**PLANNED UNIT DEVELOPMENT
STAFF REPORT****Date: October 6, 2016****DEVELOPMENT NAME**

Checker's Drive-In Restaurant, Inc.

Planned Unit Development Approval to amend a
previously approved Planned Unit Development to allow shared access and parking on multiple
building sites.

SITE PLAN

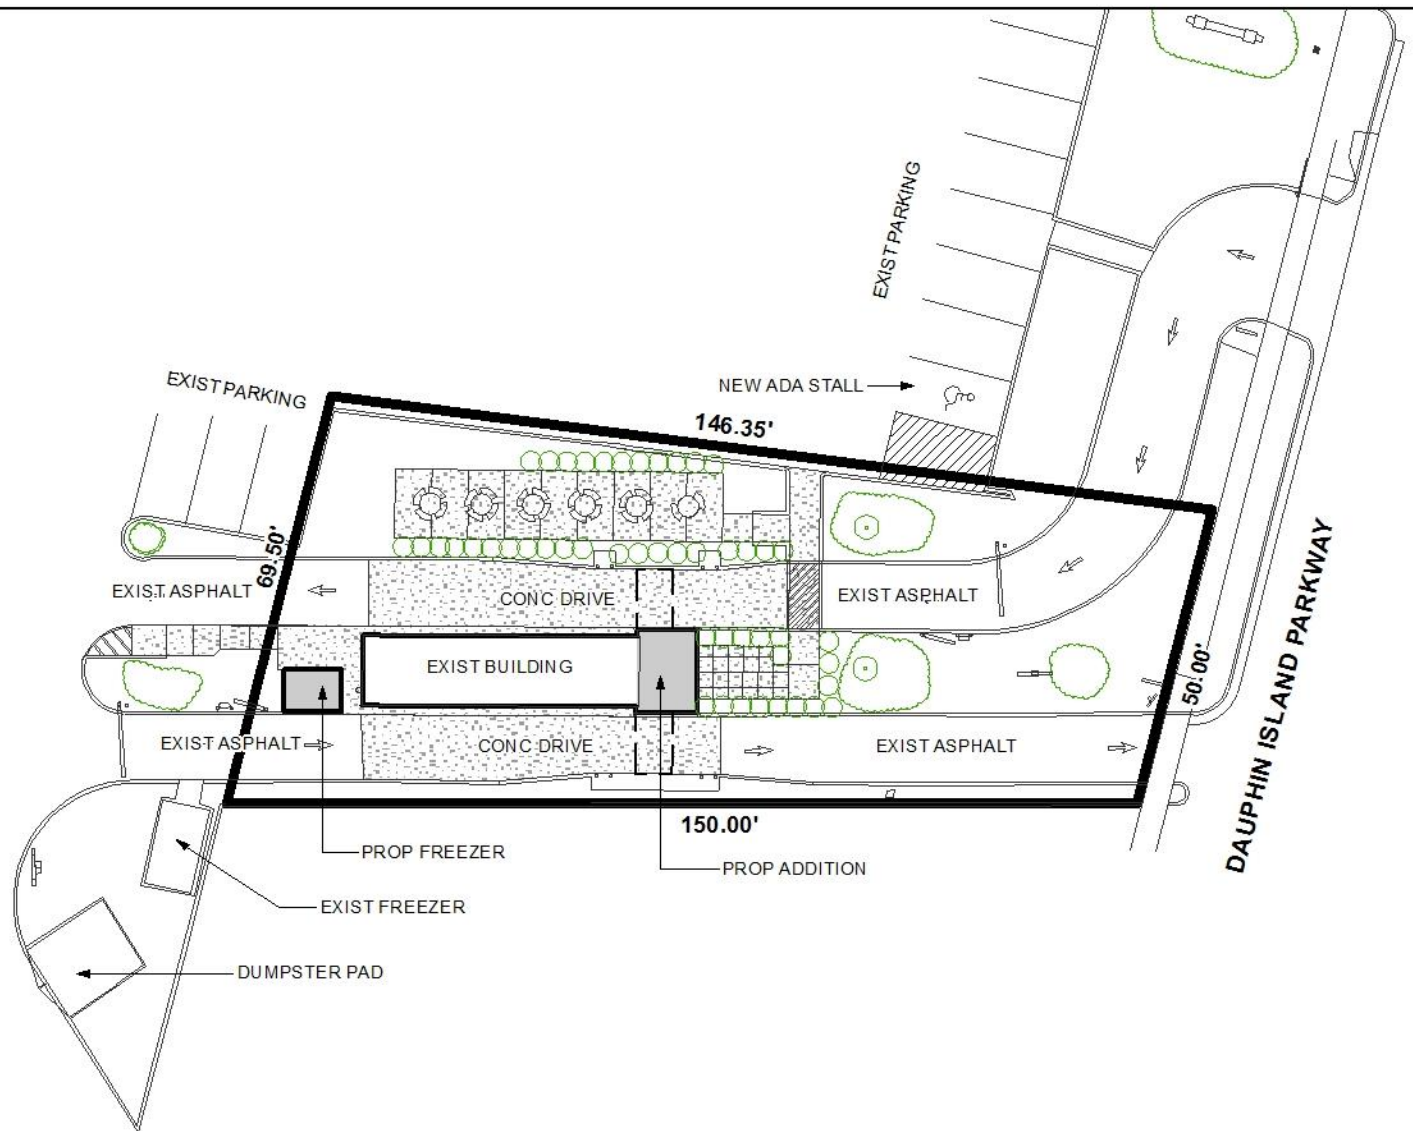
Parking is not illustrated on the site plan, therefore Staff cannot determine if the site complies with parking requirements as they are impacted by the proposed addition to the existing building;

Landscaping is proposed on the site, but not for the overall development; and information regarding landscaping is not depicted with regards to the calculations needed to ensure compliance. While no significant structural enhancements to the site are proposed that would necessitate full compliance with tree and landscaping requirements of the Zoning Ordinance, all existing and proposed landscaping and tree plantings for the entire development need to be illustrated, along with their calculations, on a revised site plan.

A dumpster enclosure is illustrated on the site plan, but is not located on the lot whereon Checker's Drive-In Restaurant is situated; and it is unclear if the existing dumpster meets enclosure and sanitary sewer requirements of Section 64-4.D.9. of the Zoning Ordinance. Again, previous Planned Unit Development approval allows shared access between the subject site and the lot on which the aforementioned dumpster is located, therefore the dumpster may be in compliance; nevertheless, it should be noted that if the subject site chooses to utilize their own dumpster, a revised site plan should illustrate its compliance with Section 64-4.D.9., or a note placed on the site plan stating curb-side pick-up will be utilized should be required.

A sidewalk is located along the frontage(s) of the subject site, but it is not clearly illustrated on the site plan. A revised site plan should clearly indicate existing sidewalks to ensure compliance with the Zoning Ordinance.

It should be noted that the site plan should be revised to illustrate the lot sizes in square feet and acres, as well as to illustrate the 25' minimum building setback line along all street frontages, in coordination with the Final Plat. Also, the site plan should be revised to depict a dumpster on proposed Lot 2 in compliance with enclosure and sanitary sewer requirements of Section 64-4.D.9. of the Zoning Ordinance, or a note should be placed on the site plan stating curbside pickup will be utilized on that lot. Any existing dumpsters should be illustrated and labeled as such.

The changes proposed by Checker's Drive-In Restaurant do not impact parking in a way that would require compliance with regulations regarding parking lot lighting. However, any new lighting on the site must comply with Sections 64-4.A.2, 64-6.A.3.c., and 64-6.A.8. of the Zoning Ordinance, and a note stating as much should be included on a revised site plan. Additionally, any new lighting on the site should be oriented in such a way that reduces the illumination of adjacent residential properties.

While not required by the original Planned Unit Development with respect to its conditions of approval, the site plan does not illustrate compliance with Sections 64-4.D.1. and 64-6.A.3.i. of the Zoning Ordinance regarding screening requirements that ensure commercial developments and parking facilities are appropriately screened from adjacent residential properties. Therefore, if approved, an appropriate protection buffer in the form of a wall, wooden privacy fence, or the inclusion of a screen planting strip is recommended where the site abuts residential properties to the North and West to ensure compliance with the aforementioned protection buffer requirements, and should be illustrated on a revised site plan(s).

- 1) revision of the site plan to illustrate the lot sizes in square feet and acres;*
- 2) revision of the site plan to illustrate a 25' minimum building setback line all street frontages;*

- 3) revision of the site plan to illustrate a dumpster on Lot 2 in compliance with enclosure and sanitary sewer requirements of Section 64-4.D.9. of the Zoning Ordinance, or provision of a note stating curbside pickup will be utilized on that lot;*

- 4) placement of a note on the site plan stating any new site lighting must comply with Sections 64-4.A.2., 64-6.A.3.c., and 64-6.A.8. of the Zoning Ordinance;*

- 5) revision of the site plan to illustrate compliance with Sections 64-4.D.1. and 64-6.A.3.i. of the Zoning Ordinance regarding screening requirements that ensure commercial developments and parking facilities are appropriately screened from adjacent residential properties;*
